Agenda
Zoning Board of Appeals
Wednesday, November 28, 2018 - 7:00 P.M.
City Hall-Council Chambers, 1 S Huron St
Ypsilanti, MI 48197

- 528, 530 and 534 N Huron- Variances
 - o §122-607(a), Building Entrances, Rights of Way, and Easements
Public Hearing
 - o §122-477, Commercial Frontage Requirements
Public Hearing

- 307 N River- Variances
 - o §122-672, Sidewalks
Public Hearing
 - o §122-683, Off-Street Parking Layout and Construction
Public Hearing
 - o §122-684, Parking Screening and Landscaping
Public Hearing
 - o §122-685, Parking Dimensions
Public Hearing
- 2019 Schedule of Meetings

Project Name:
STORE- 534 N. HURON STREET
534 N. HURON STREET
YPOCLANT, MI 48197
OWNER:
TOM TAMOU

Figure 6: Staff Calculations for Frontage

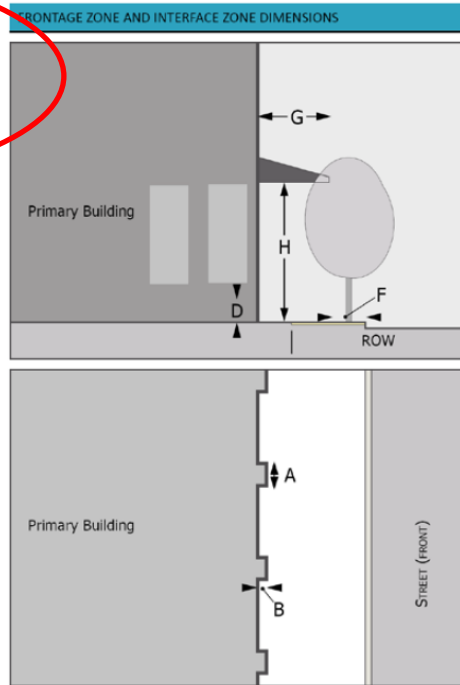
Façade dimensions	Required- Zoning Ordinance	N Huron-Addition	
		Proposed	Knockout
Distance between openings	Max: 2 ft	1'4" to 12'6"	
Frontage area	n/a	12' tall frontage: 528 sf (60% = 316.8 sf) 9'4" tall frontage: 409 sf (60% = 245.4 sf)	
Ground floor transparency (%)	Min: 60%	8.8 % (12' tall) 11.3 % (9'4" tall)	38.2 % (12' tall) 49.3 % (9'4" tall)
Height to bottom of window	Max: 2.5 ft	6'	1'4"

There are slight discrepancies between the staff calculations for frontage area and the applicant's calculations. Staff measured a 44' wide addition, with either a 12' tall frontage (standard first story height per zoning) or a 9'4" tall frontage (matching existing first story height), calculating 528 square feet and 409.2 square feet, respectively. The applicant used a figure of 351.8 sf.

PROPOSED SITE PLAN

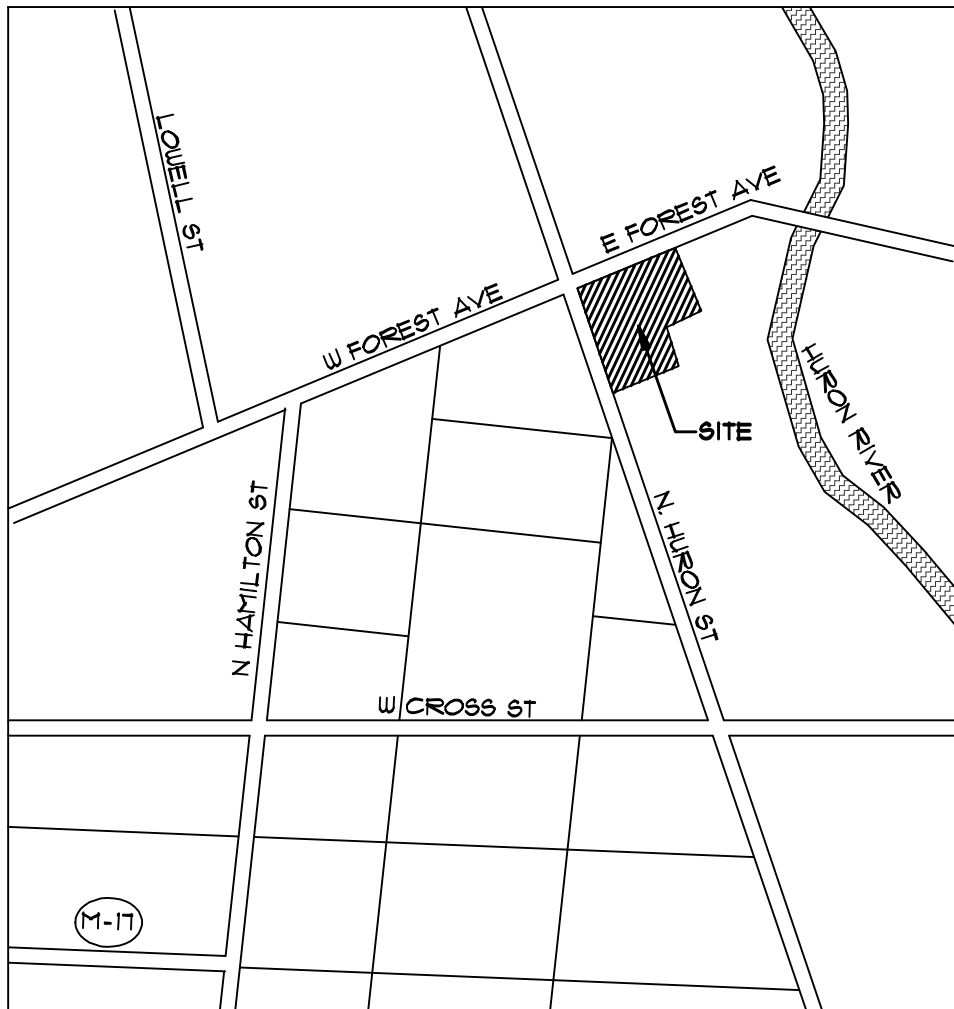
Additionally, concerning Section 122-607(a) with regard to the front entry, the site plans will be revised to provide for the entrance to the building on a 45-degree angle at the southwest corner of the proposed addition, abutting both N. Huron Street and the building's parking lot."

6. Additionally, concerning Section 122-607(a) with regard to the front entry, the site plans will be revised to provide for the entrance to the building on a 45-degree angle at the southwest corner of the proposed addition, abutting both N. Huron Street and the building's parking lot.

WEST ('FRONT') ELEVATION

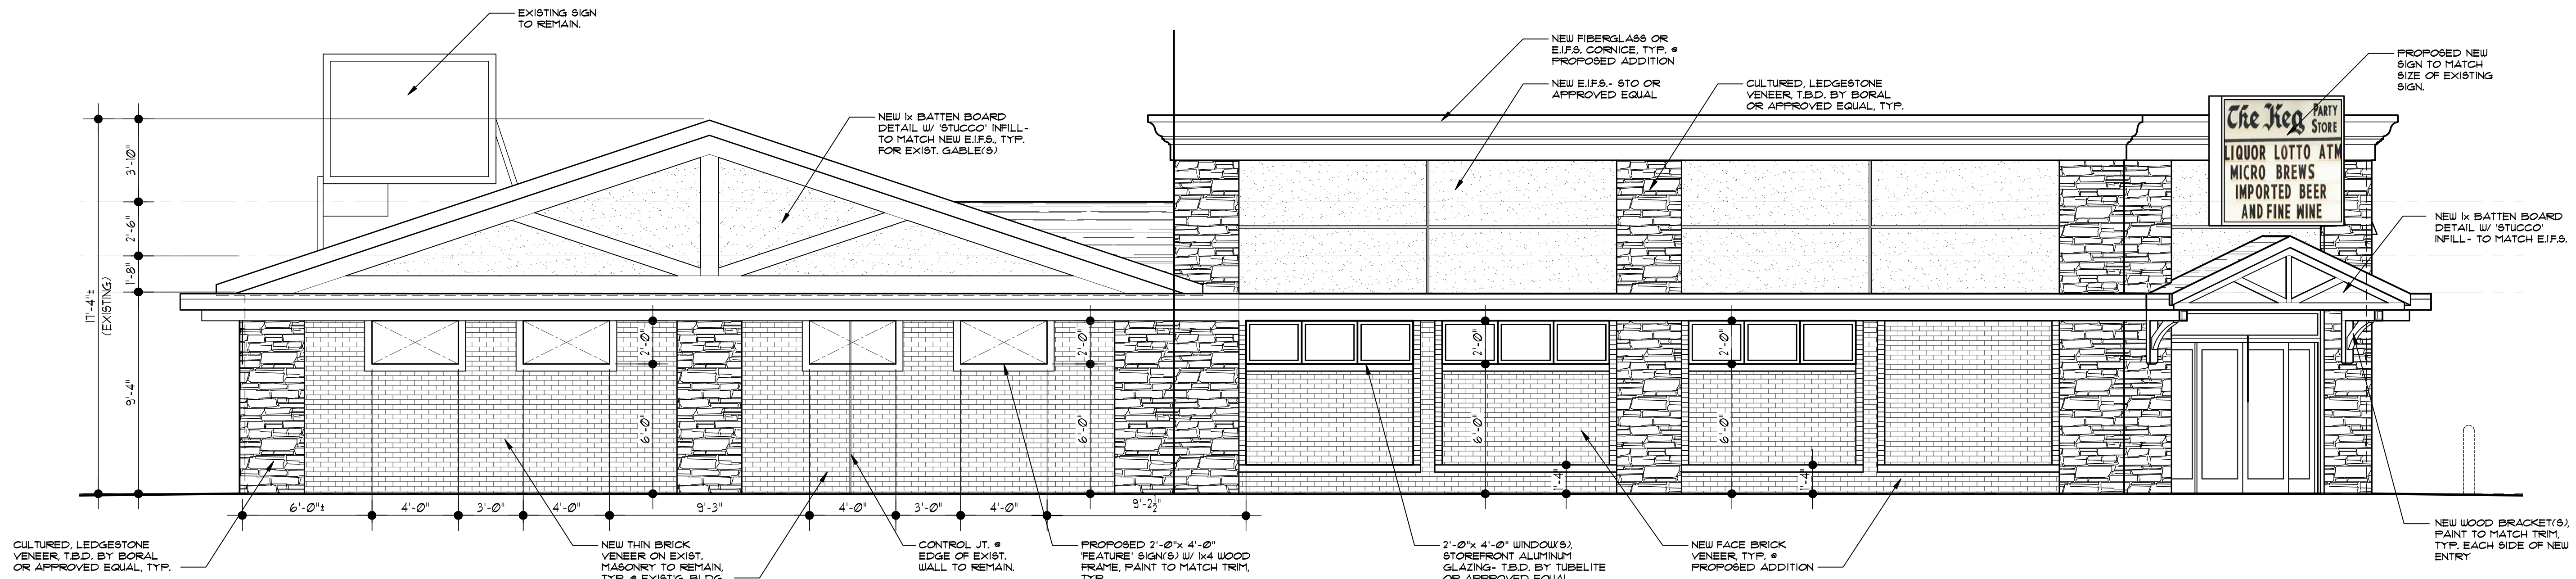
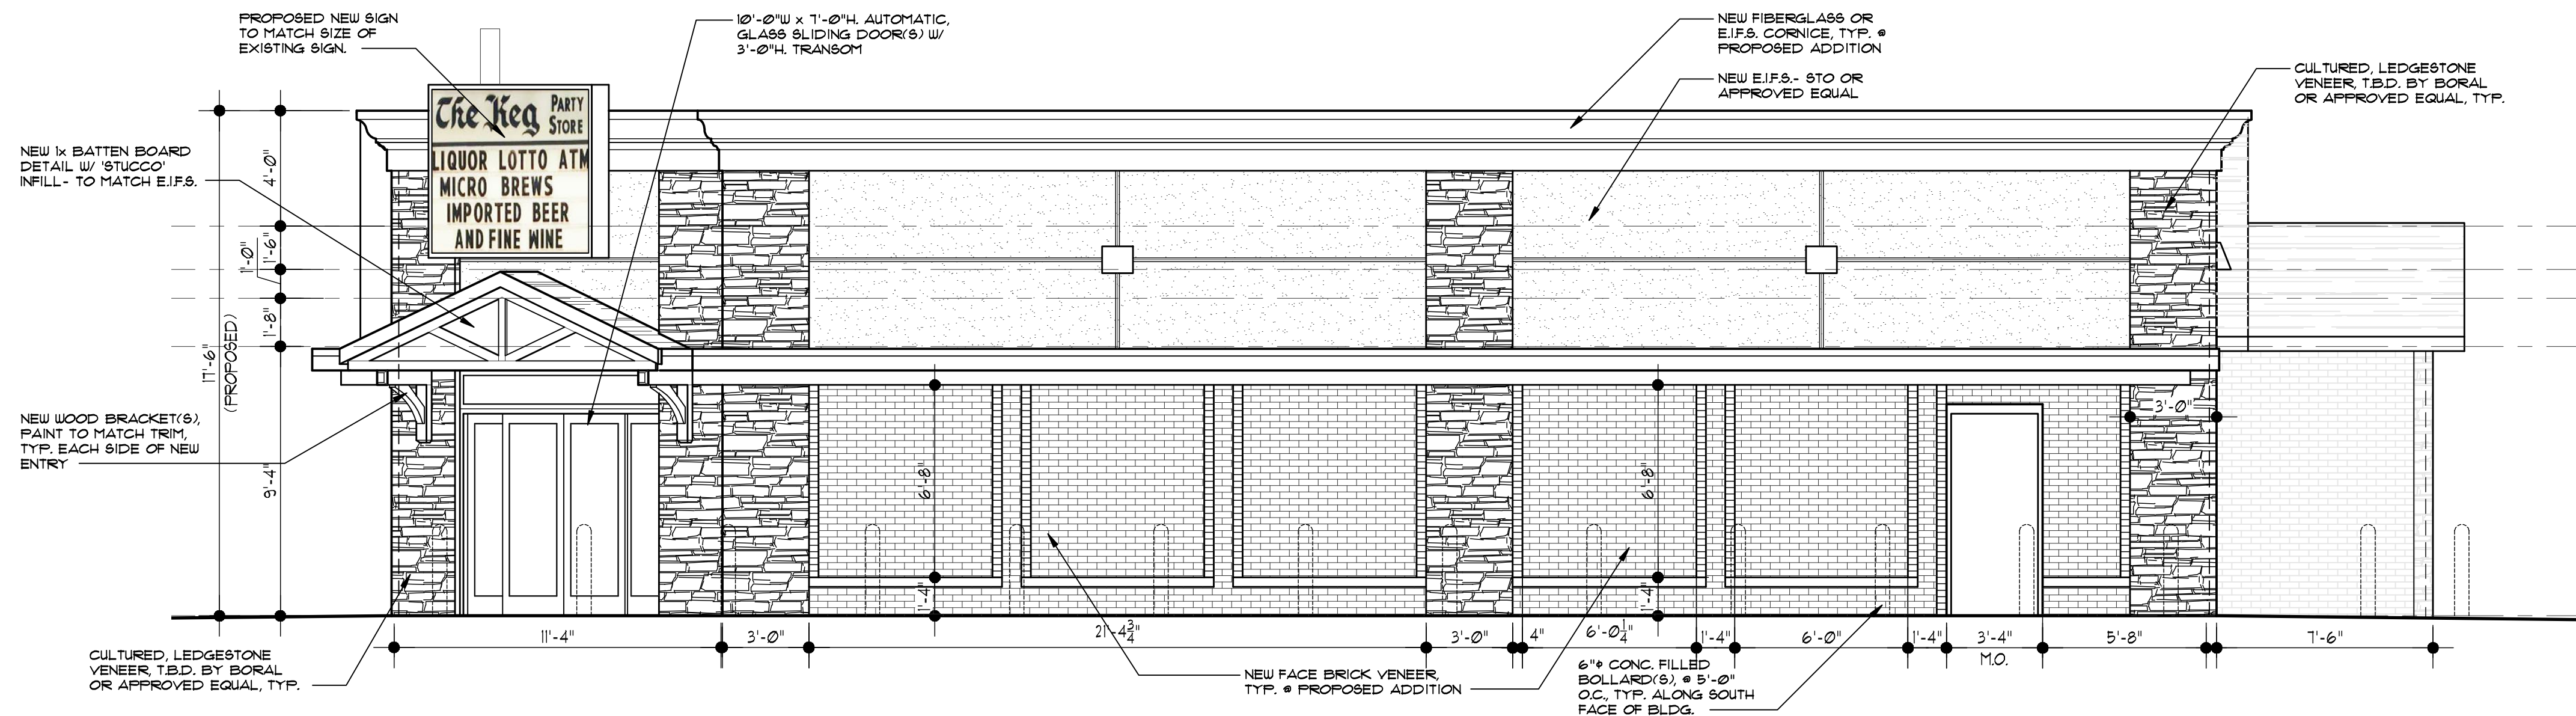
The applicant is proposing a 3,520 square foot addition to the existing 2,774 square foot building for a total of 6,294 square feet at the northwest corner of the parcels. The plans also call for the demolition of the existing 1,200 square foot structure at 530 N Huron. Parking is proposed to the south of the structure. The building is addressed to N Huron. The proposed addition does not comply with the required commercial private frontage as required by §122-477 and described in §122-484, as it has only ~8.8% ground floor transparency (see calculations on page 9) on the N Huron addition, not the required 60%. The distance between

The additional windows in the currently proposed plans are more than what were proposed in the site plans from 3-22-2018 for the previous variance, which only indicated a 3% transparency on the new addition and no windows on the existing non-conforming structure.

FRONTAGE ANALYSIS PER ORDINANCE	
'WEST' / N. HURON STREET FACE (* ADDITION):	'SOUTHWEST' / CORNER ENTRY FACE:
PROPOSED ADDITION: 351.8 SF.	PROPOSED ADDITION: 136.0 SF.
x 60%	x 60%
WINDOW AREA REQUIRED: 211.1 SF.	DOOR/ WINDOW AREA REQ'D: 81.6 SF.
TOTAL WINDOW AREA PROP. (INCLUDING BLOCKOUT AREAS): 206.5 SF. (58.1%)	DOOR/ WINDOW AREA PROP.: 85.0 SF. (62.5%)
WINDOW GLAZING, INSTALLED: 46.5 SF. (7.6%)

FRONTAGE ANALYSIS PER ORDINANCE	
'SOUTH' / PARKING FACE (* ADDITION):	
PROPOSED ADDITION: 414.3 SF.	
x 60%	
WINDOW AREA (* 60.0%): 248.6 SF.	
TOTAL WINDOW AREA PROP. (INCLUDING BLOCKOUT AREAS): 244.7 SF. (59.1%)	
DOOR, AS INSTALLED: 24.5 SF. (5.9%)

SP1.00

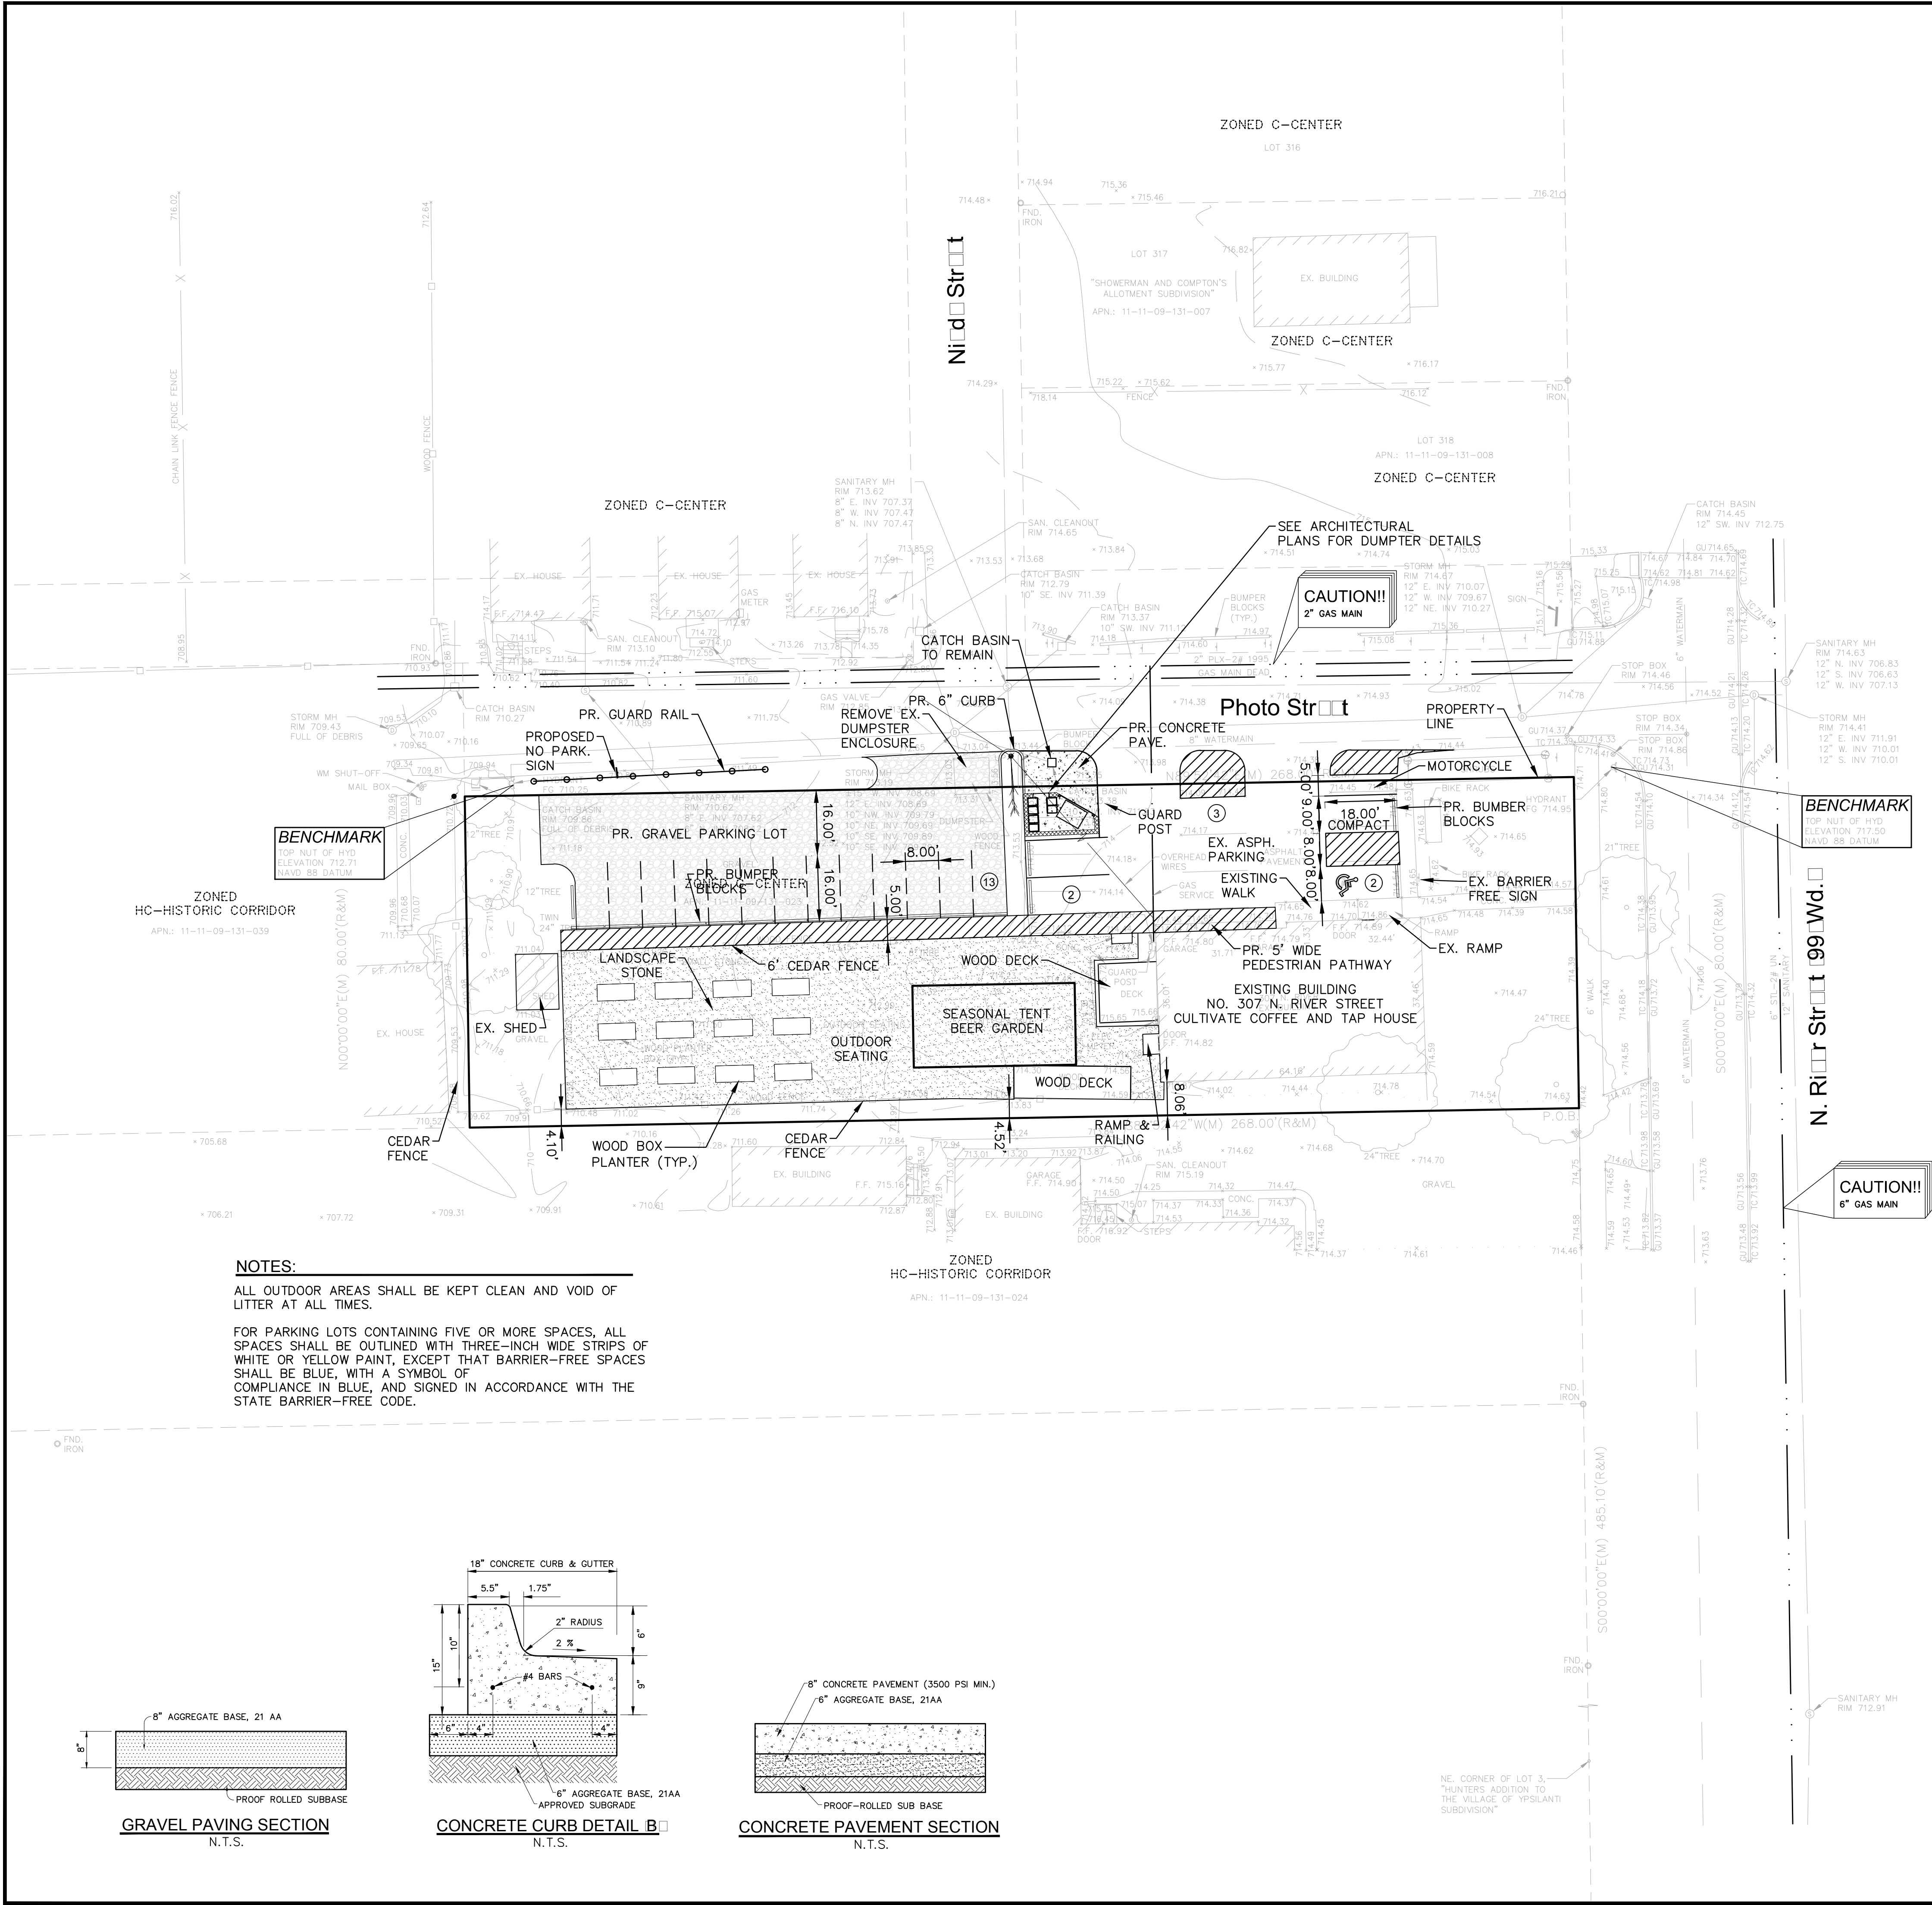
The applicant notes that it would be difficult to provide sidewalk, landscaping, and curbing along Photo St. due to its unique design. Photo is a short street that lacks curb & gutter; the current paved parking area is paved to the edge, and the new gravel area is also graveled to its edge. The area, in general, is highly connected. The zoning ordinance dictates that the remedy for impractical sidewalk placement is a fee in lieu of construction. The applicant is asking a variance to both not provide a sidewalk and not provide the fee-in-lieu.

(b)(3) aisle protection: The applicant is not required to add parking per the code. The previously existing parking layout with seven spaces would have been acceptable as legal nonconforming under the code, with the conversion of one space to barrier-free. The proposed layout is of the applicant's choosing.

(c)(2) screening: The applicant is not required to add parking per the code. The addition of the graveled area was done without benefit of site plan or, staff believes, measurement to ensure it would serve parking needs adequately. The supposed need for a variance is entirely self-created.

- The applicant will provide wheelstops to indicate proper parking layout;
 - The granting of this variance will not be detrimental to the public welfare.
